Re: 35 Elsworthy Road, London NW3 3BT. Update of Tree Schedule and Tree Protection arrangements.

TREE PROTECTION PLAN

TSP/TPP/ER MAY 2022- REV B
 20 JULY 2022 - trench sheeting relocated
 E: treeprojects@hotmail.com M: 07788 726 720

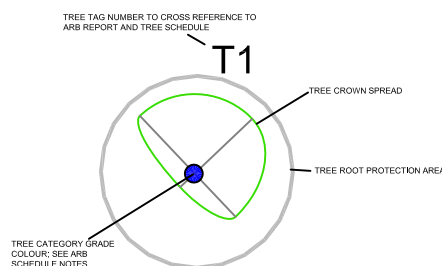
- Addition of trench sheeting to control risk of collapse adjacent to/ beneath ground protection
- Addition of protection to London Plane street tree.
- Provision to assess roots, by way of an investigative trench, of off site trees at 37 Elsworthy Road namely *Roninia* trees T19 and T20.

TRENCH SHEETING TO ABUT OUTER FACE OF GROUND BEAM, IN-BOARD AND ADJACENT TO STEEL ROAD PLATES ABOVE (WHERE APPLICABLE).

INSTALL TRENCH SHEETING EXCEPT IN PROXIMITY TO ROBINIA T19 AND T20, PROCEED TO INSTALL STEEL ROAD PLATES TO BUT WITH TRENCH SHEETING AND LAY ON LEAN DRY MIX BED. INSTALL TREE PROTECTIVE BARRIER AS PER TREE SPECIALIST DETAIL USING PROPRIETARY BACK BRACING TO BLOCK AND MESH FENCING. TREE PROTECTION TO BE INSPECTED AND SIGNED-OFF BY TREE SPECIALIST.
